Natural England, Marine Management Organisation & Cefas review of G4.9 Marine Processes
Supplementary Report - Revision: 01 [REP4-043]

The construction and operation of Hornsea Project Four Offshore Wind Farm, located approximately 69 km from the East Riding of Yorkshire in the Southern North Sea, covering an area of approximately 468 km².

Planning Inspectorate Reference EN010098

Subject: Hornsea Four: Marine Processes Supplementary Report, Doc. Ref. No: G4.9 (Rev 01) [REP4-043]

Figure 1. Comparison of 1979-2020/21 bathymetric survey data (taken from Ørsted, 2022)

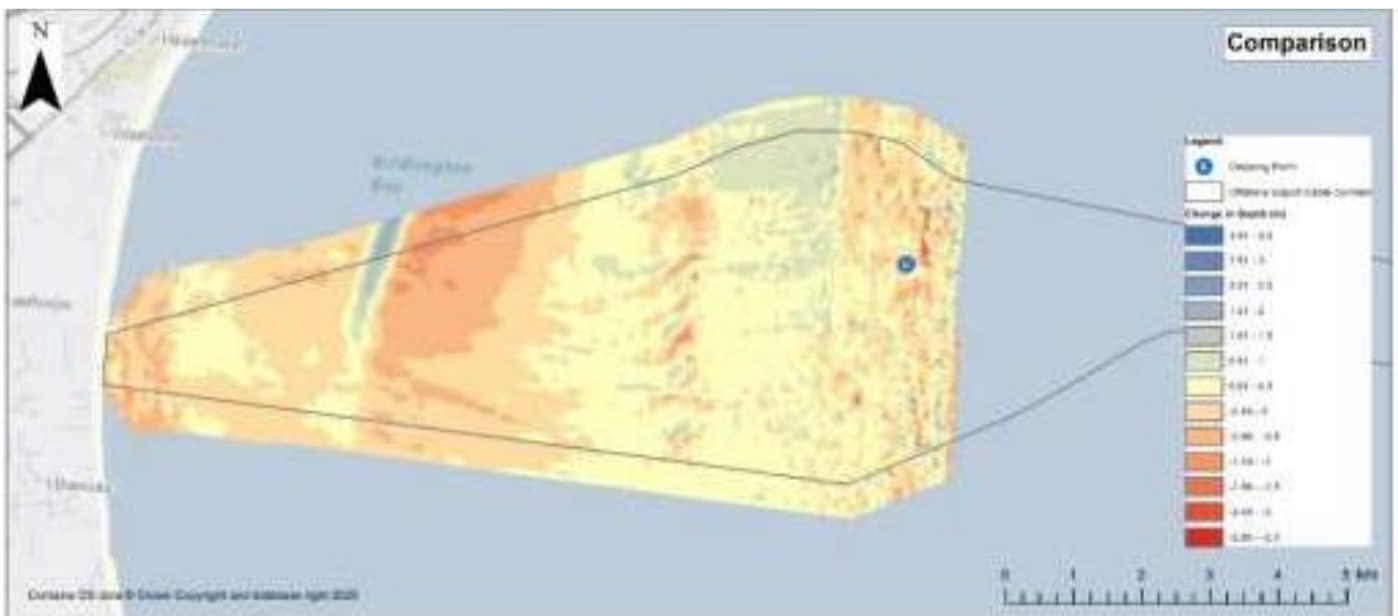
A vital part of establishing the pre-construction baseline for the Hornsea Four marine processes impact assessment, with regard to Smithic Bank, is defining the geographical extent of the sandbank. Figure 1 below shows the comparison of the 1979 and 2020/21 bathymetric data, what is not clear is the location of the geomorphological eastern boundary (flank) of Smithic Bank relative to the Dogger Bank A & B Cable Crossing location. The combined effect of increased seabed roughness, decreased water depth, and a potential barrier to sediment as a result of the crossing elevating the seabed could influence sediment transport processes, which in turn could trigger morphological change(s). We would, therefore, advise that the geomorphological boundary and extent of Smithic Bank should be defined as accurately as possible, presented on the latest Dogger Bank A & B Cable Crossing map, and agreed with Natural England, MMO and Cefas.

Figure 1 above shows comparison of the 1979 and 2020/21 bathymetric data for the Dogger Bank A & B Cable Crossing. This shows that there is evidence for up to 2.5m bathymetric change at the Dogger Bank A & B Cable Crossing site over the period 1979-2020/21 which raises concerns regarding the potential for morphological change.

Figure 3. Image showing the formation of sediment plumes in the lee of offshore windfarm turbines

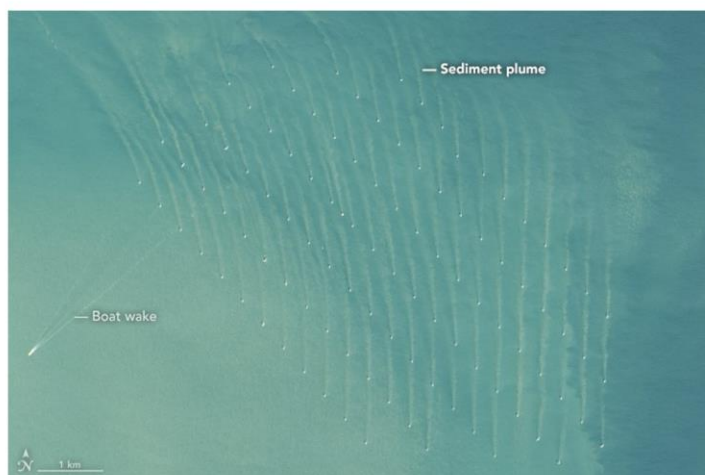
We are also concerned that cold water plumes could form in the lee of the foundation structures of the Hornsea Four array, thus altering the sea temperature. In Figure 3 below, a hypothetical scenario is described in which cold water plumes are seen to develop in the lee of a **monopile** foundation structure as the tidal currents continuously move past. It is feasible that cold water plumes could form in a similar manner to sediment plumes that have been observed in the lee of existing WTG foundation structures due to scouring of the seabed. These cold-water plumes could, on an array-scale, also have a significant ecological impact on the primary production and the wider marine ecosystem. The use of GBS is likely to intensify the likelihood of these arising.

1. Say 10 GBS/Monopiles on ebbtide edge of licence areas ebb frontage each of (worst case) 50m diameter
2. Say, Packing density along this axis is 1 in 1000m
3. Therefore each plume (at worst (2d)) is 1/10th of area
4. The ecological impact of each plume is associated with high nutrients rather than temperatures
5. Question – beyond core advice

What is the significance of this in terms of primary productivity? Coupled with the frequency, duration and intensity of the front crossing these areas?
